## REPAIR PROCEDURE

**APPLICABILITY:** 2009-2012MY Forester  
 2010-2011MY Legacy and Outback  
 2006-2012MY Tribeca

**DATE:** January 2013

**SUBJECT:** Preliminary Inspection and Repair Procedure  
 for Puddle Light Campaign WQE-41

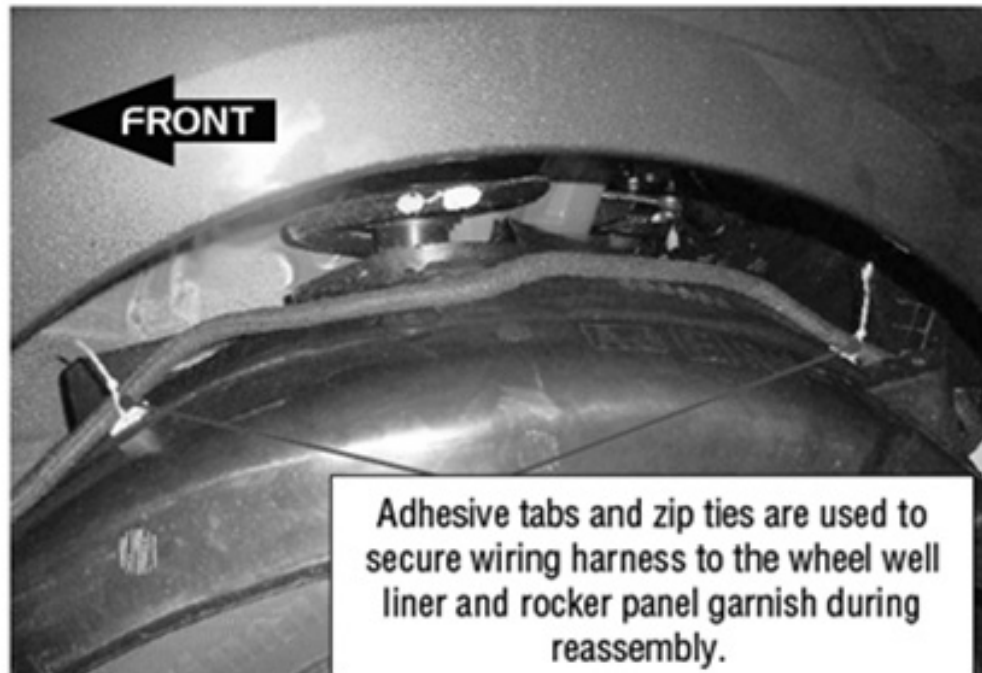
- A Forester is shown in the photo on pg. 4 for illustration only.
- Splash guard removal may also be required for access to the splash shield retaining clips.
- Retaining clip locations will vary by model.
- See **Appendix B** for samples of retaining clip locations by model.
- The photos below show a puddle light harness without the in-line mini-fuse on the left and the current replacement harness with the in-line mini-fuse on the right.

**No mini-fuse installed**

**With mini-fuse installed**

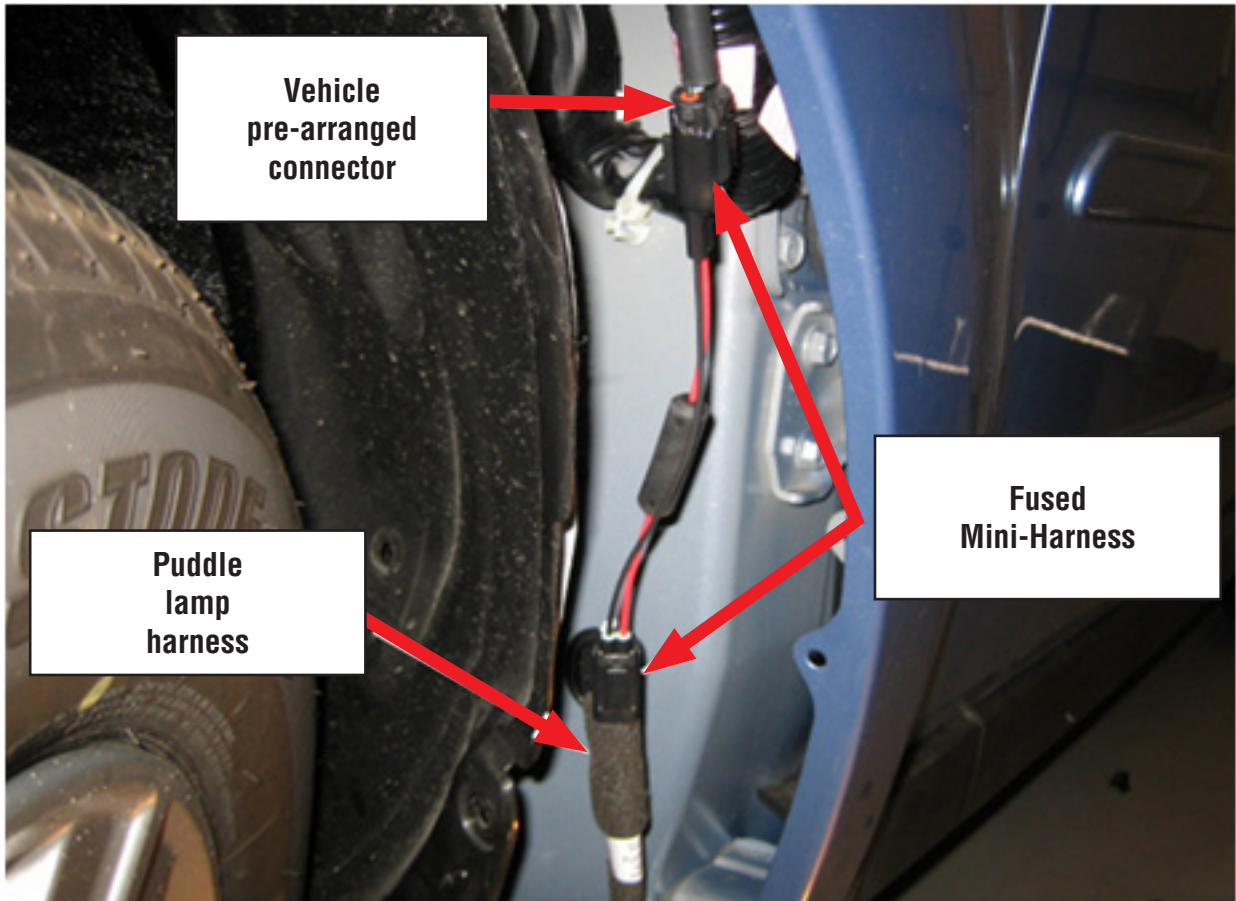
3. Once the splash shield has been moved enough for access, inspect the puddle light harnesses.
  - a. If the vehicle already has an in-line fuse in the red power wire within a few inches of the vehicle connector as shown in the photo below and both lights (all 4 LED bulbs) operate, no further action is required on that side.
